AUTOMATIC TRANSMISSION SERVICE GROUP

**REVISED EDITION**

Since the introduction of the THM 440-T4 Transaxle in April, 1984, there have been many major engineering design changes. These changes have affected nearly every part used in the THM 440-T4. This Update Handbook will explain each change, the parts affected by the change, and any parts interchangeability problems created by the change.

Figure 42

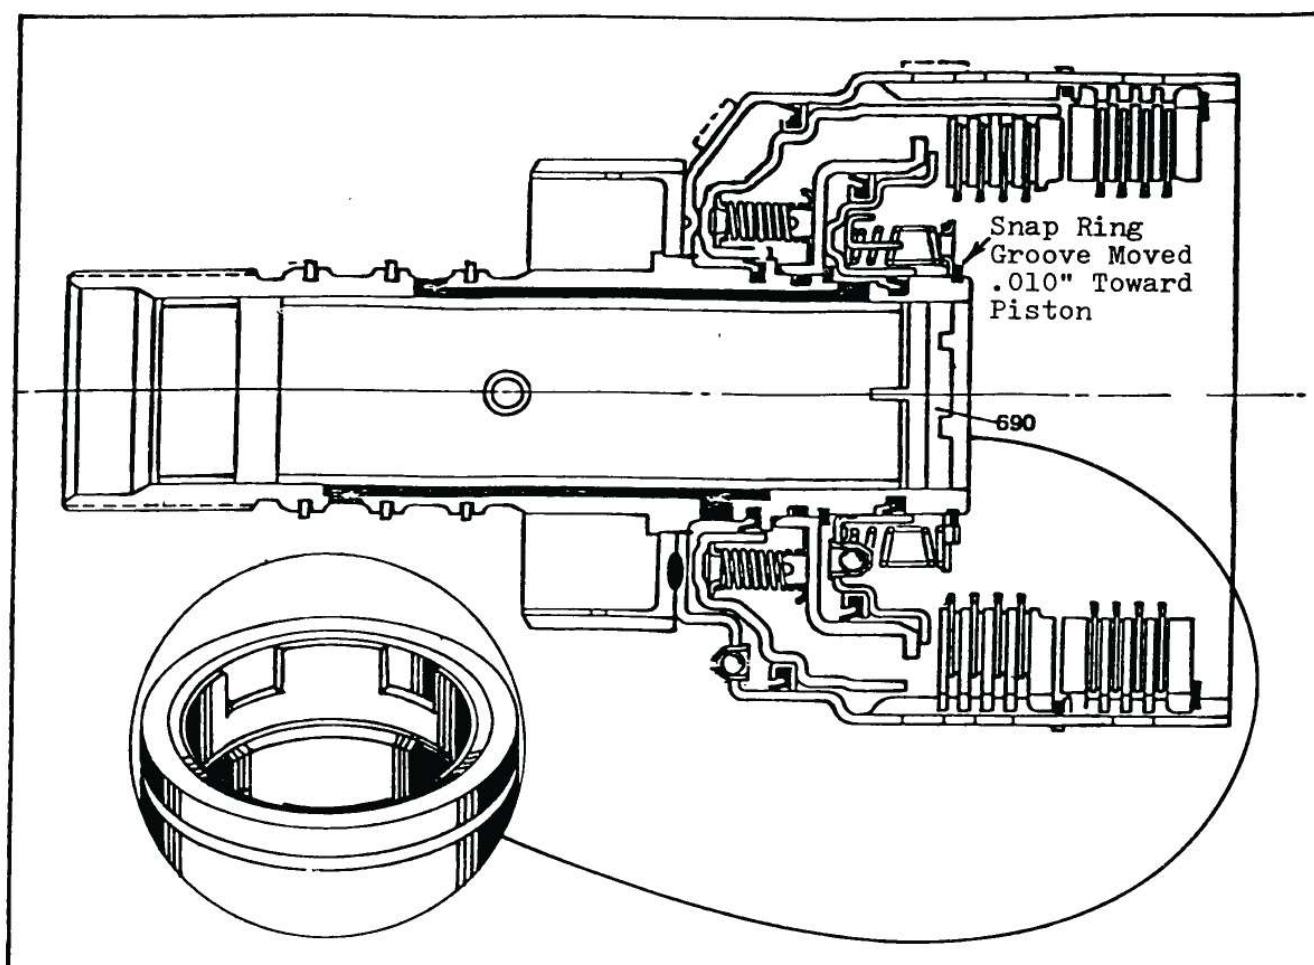
- 1) 3rd Roller Clutch, Outer Race - Modified to accept the added oil dam.
- 2) 3rd Clutch Return Spring Assembly - Tabs removed from top of return spring assembly, because of interference with added oil dam (See Figure 41).
- 3) Input Housing - Snap ring groove moved .010" toward the 3rd clutch piston. This was done to move the 3rd clutch return spring assembly an additional .010" away from added oil dam for added clearance (See Figure 42).

NOTE: If new input housing is purchased, be sure to remove (690) sleeve from old input housing and reinstall in the new input housing, as it does not come with the new input housing (See Inset, Figure 42).

Figure 44

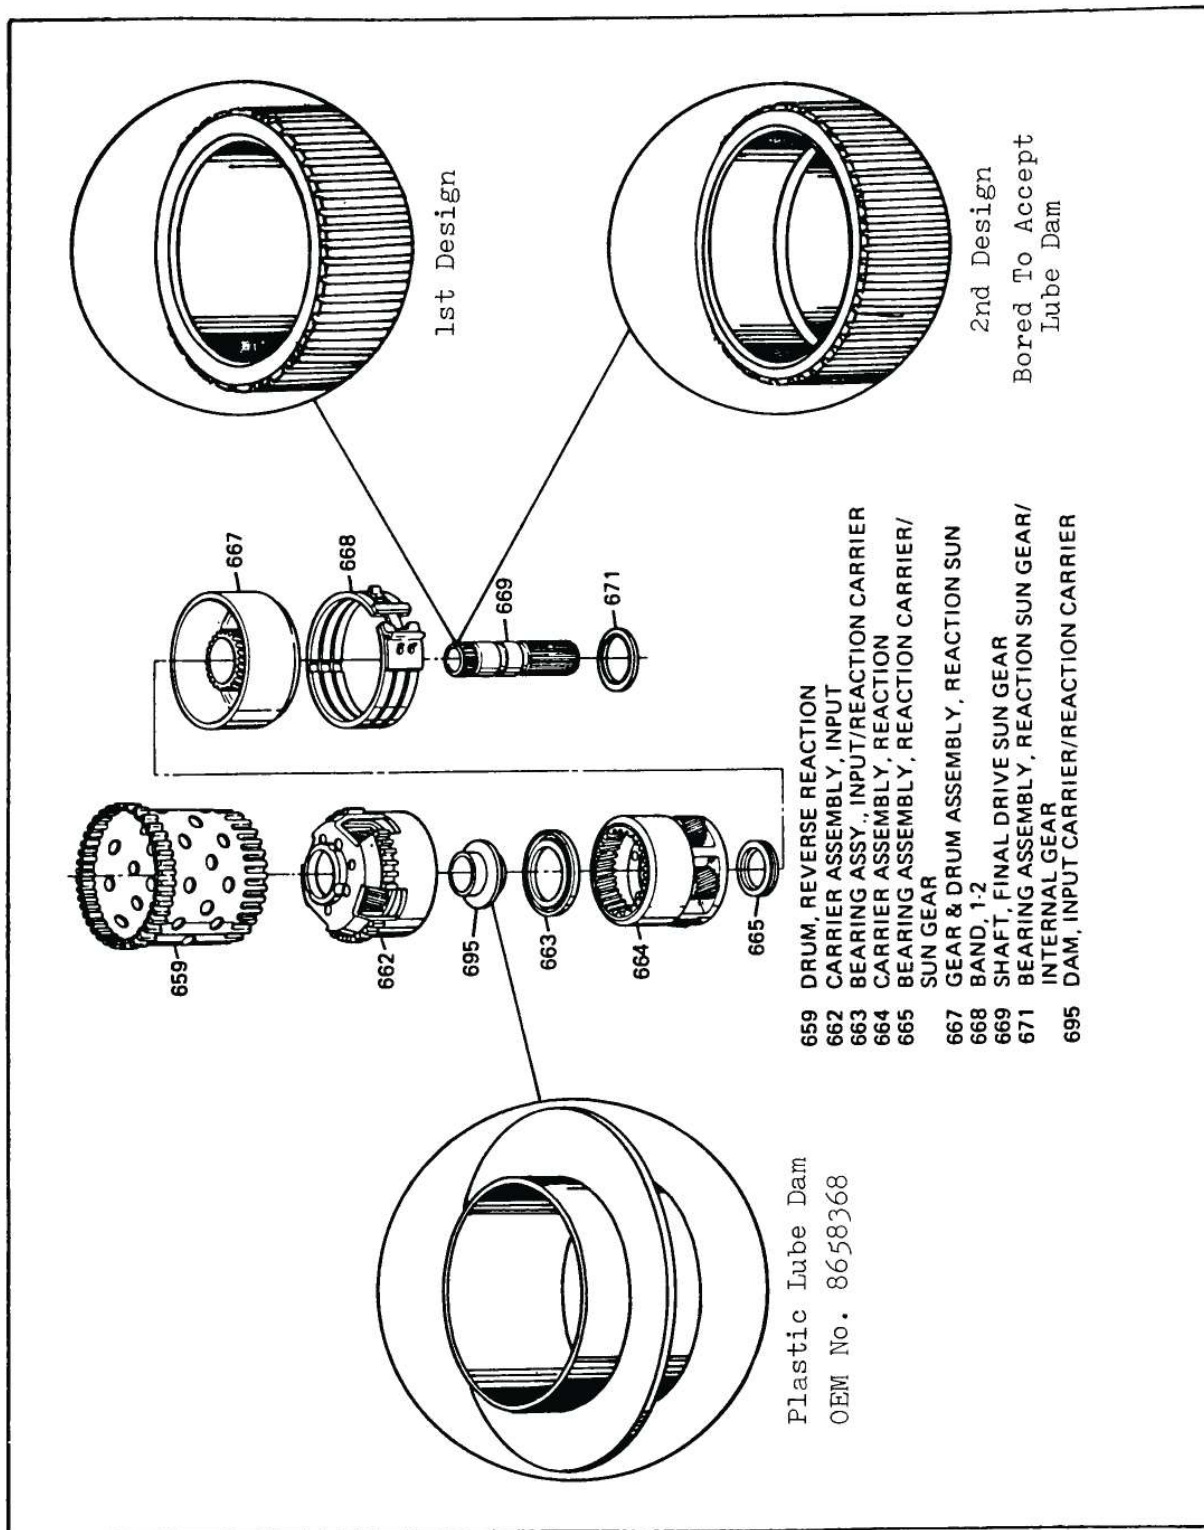
Change: Addition of plastic lube dam (695) between carriers.
(See Figure 44).

- 1) Input Carrier(662) (Figure 44) - Bored larger on inside diameter to accept added lube dam.
- 2) Output Shaft(565) (Figure 45) - Machined shoulder on output shaft to accept added lube dam (See Inset, Figure 45).
- 3) Final Drive Sun Gear Shaft(669) (Figure 44) - Inside diameter bored larger on one end to accept added lube dam. (See Inset, Figure 44).

Figure 45

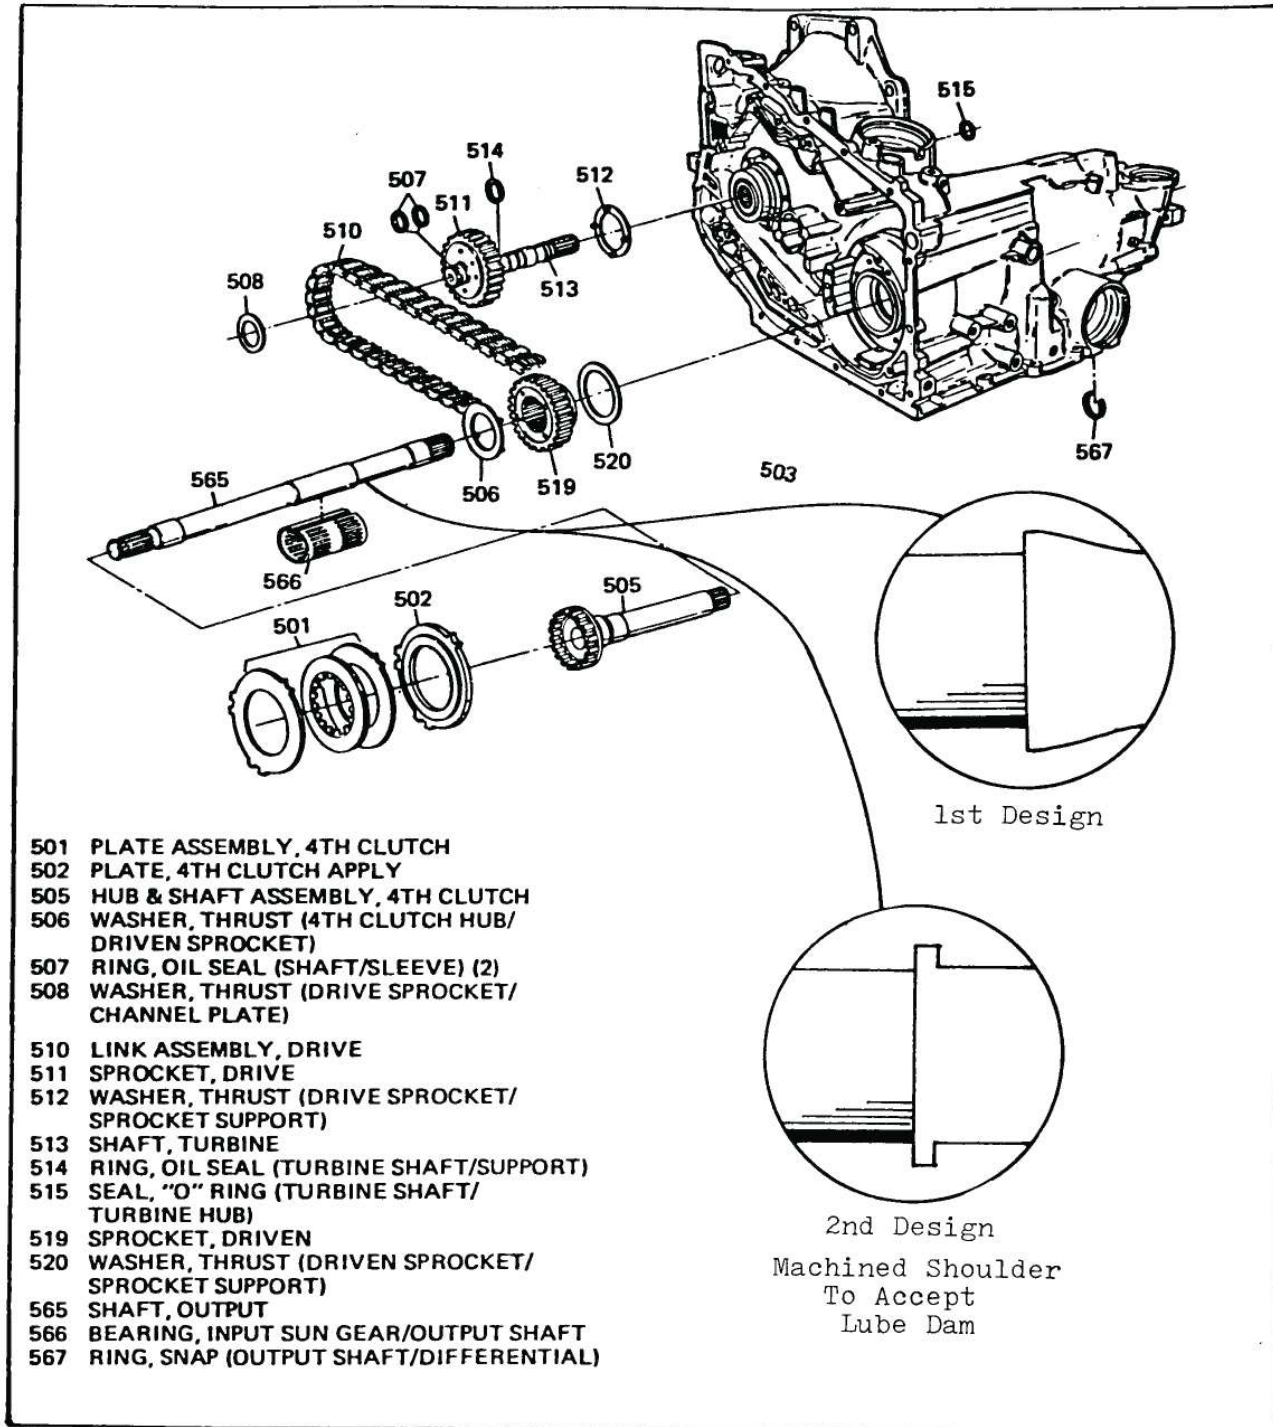
Reason: Improved durability by retaining more lube oil on output shaft bearing(566) (Figure 45). This bearing rides inside of the input sun gear.

- * 7) Plastic Lube Dam(695) - Input carrier bored to accept dam.
- * 8) Output Shaft(565) - Shoulder machined to accept lube dam between the carriers (See Figure 45).
- * 9) Final Drive Sun Gear Shaft(669) - Bored the inside diameter to accept lube dam between the carriers (See Figure 44).

Figure 46

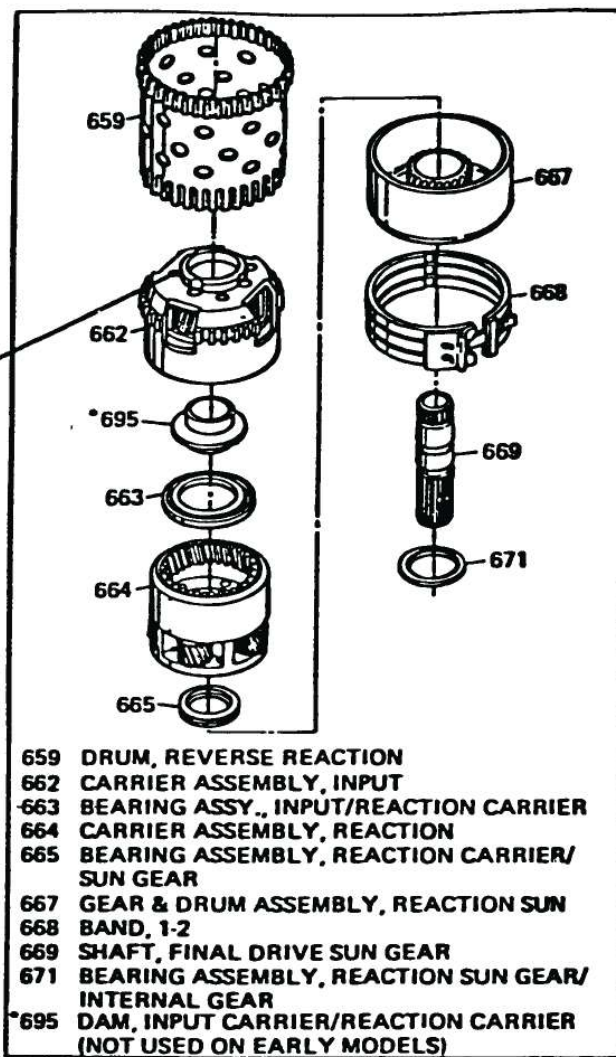
- 1) Input Sprag Assy(653) - Length of sprags increased by .095" and redimensioned end plates.
- 2) Outer Race(654) - Wider by .050".
- 3) Inner Race(650) - Wider by .142".
- 4) Retainer(655) - Shallower by .065" (See Figure 49).
- 5) Spacer(657) - Thinner by .142" (See Figure 49).
- 6) Input Carrier(622) - Shoulder machined down to shorter dimension (See Figure 46).

CAUTION: The input carrier must be replaced or modified as per specifications in Figure 46. If not replaced or modified, an interference will result and damage to the transaxle. The lip protruding on top of the input carrier must be machined to meet the dimension shown in Figure 46. Extra care must be used in the machining process, as the torrrington bearing will not come out of the input carrier.

Figure 51

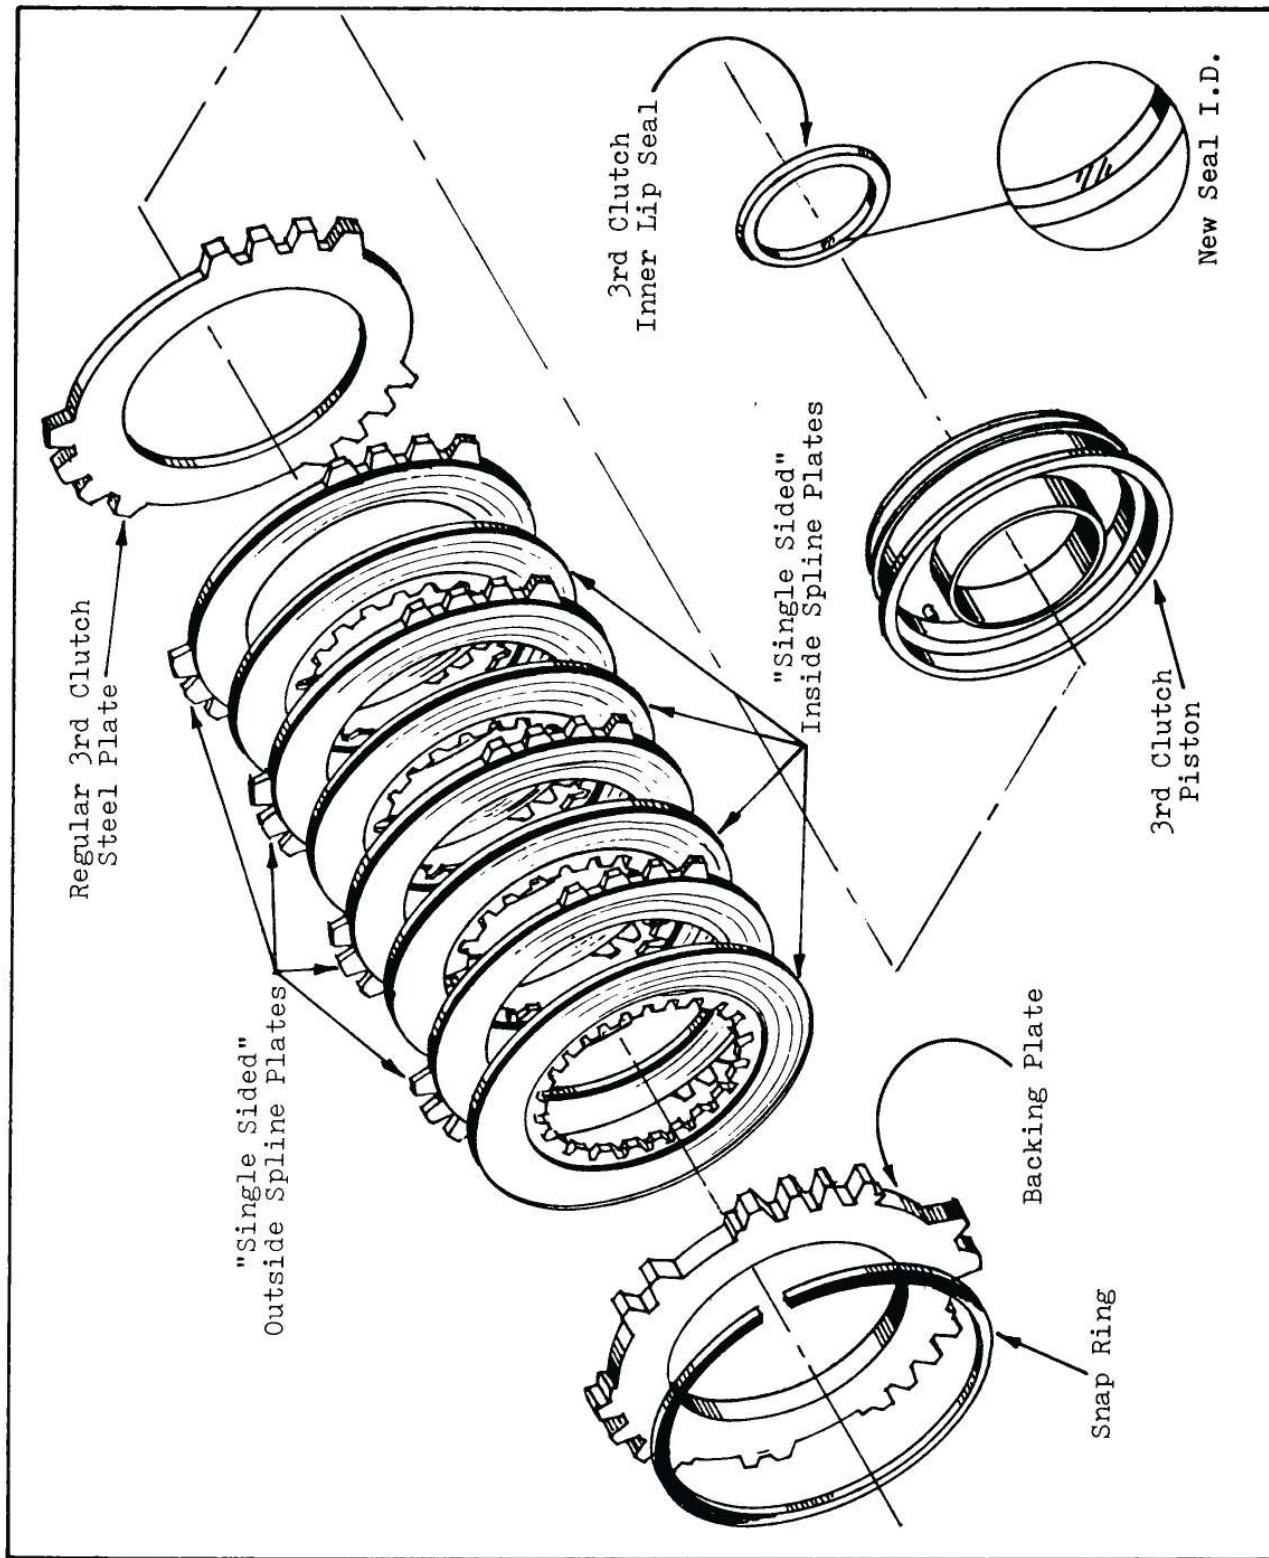
1st Change: Single Sided 3rd Clutch Plates - Lining on one side only both inside and outside spline plates (See Figure 51).

Will retro fit backwards, and is recommended. New OEM Part No. is 8662673 on the new 3rd clutch lip seal. For positive identification of the new seal, check for hash marks on inside diameter of lip seal (See Inset, Figure 51). For difference in profile compare Inset "A" and "B" in Figure 52.

Figure 52

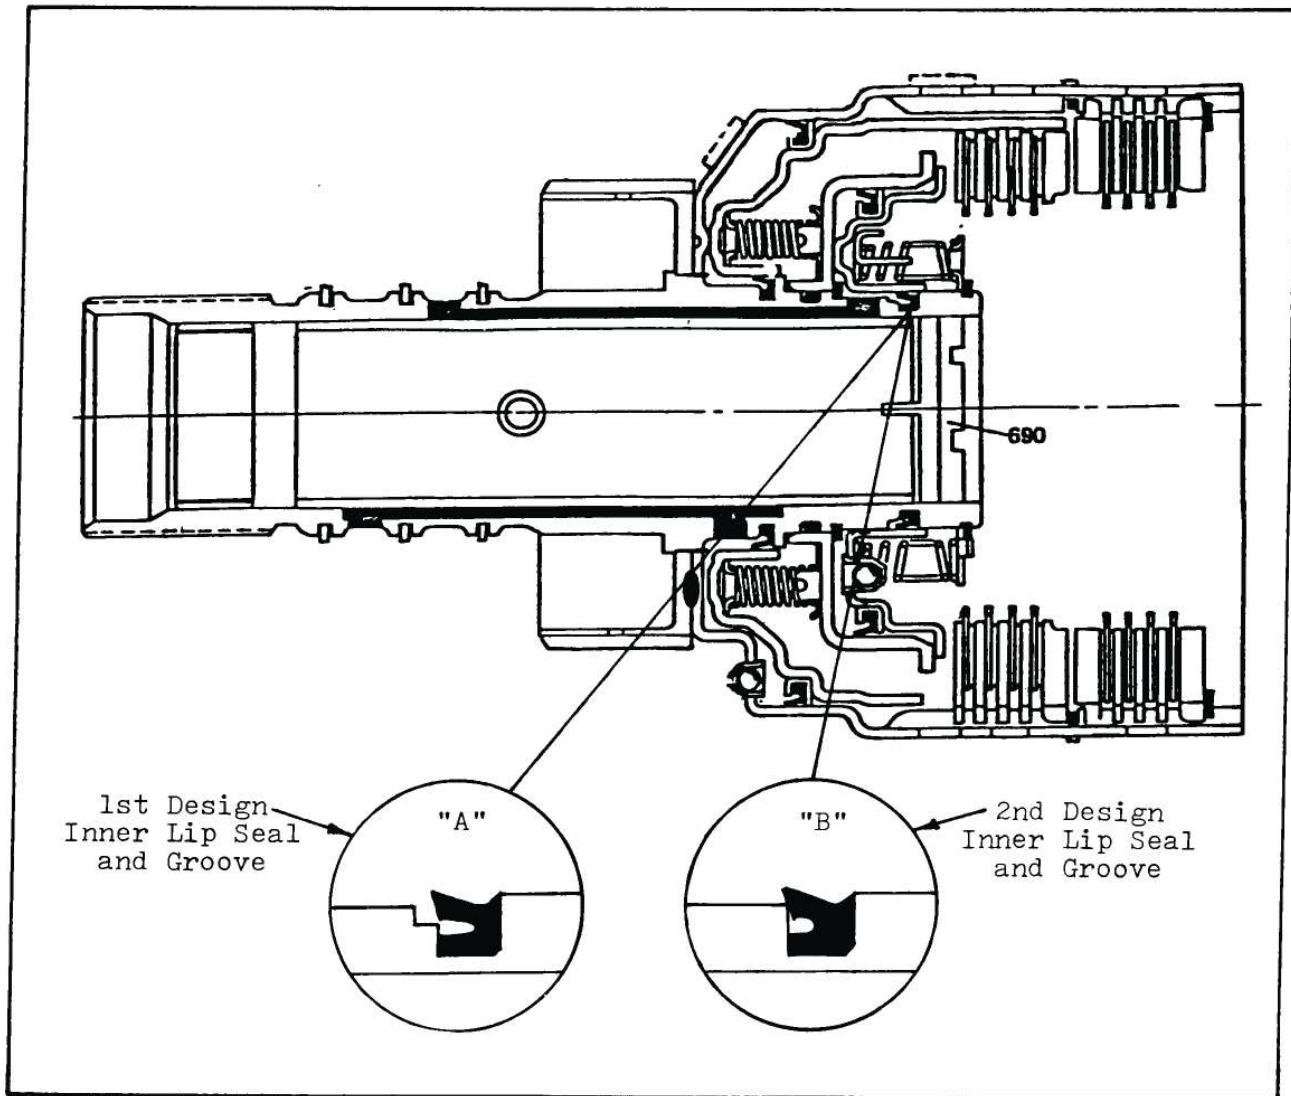
- 1) 3rd Clutch Inner Lip Seal - Thicker profile to help prevent seal from rolling (See Inset, Figure 52).

3rd Change: Input/3rd Clutch Housing - Revised 3rd Clutch Inner Lip Seal Groove (See Figure 52)

- 1) Input/3rd Clutch Housing - One machining process eliminated in groove for the 3rd clutch inner lip seal, which provided more support for the lip seal to prevent it from rolling.
(Compare Inset "A" and "B", Figure 52).

Figure 53

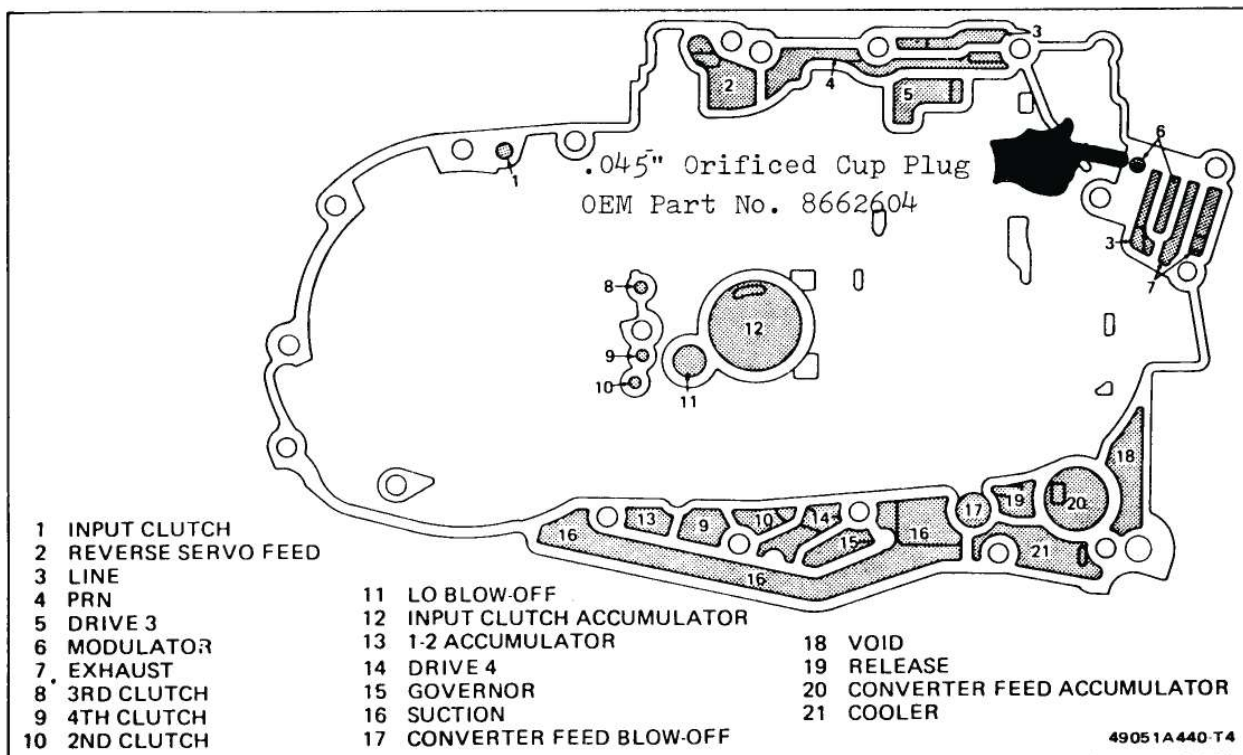
- 1) Vacuum Modulator - Late design has plunger sticking out of modulator (See Figures 54 and 55).
- 2) Modulator Valve - Redesigned to be compatable with "Plunger" style modulator. (Stem Removed--See Figures 54 and 55).
- 3) Channel Plate - Orificed cup plug added to channel plate to stabilize modulator valve action (See Figure 53).
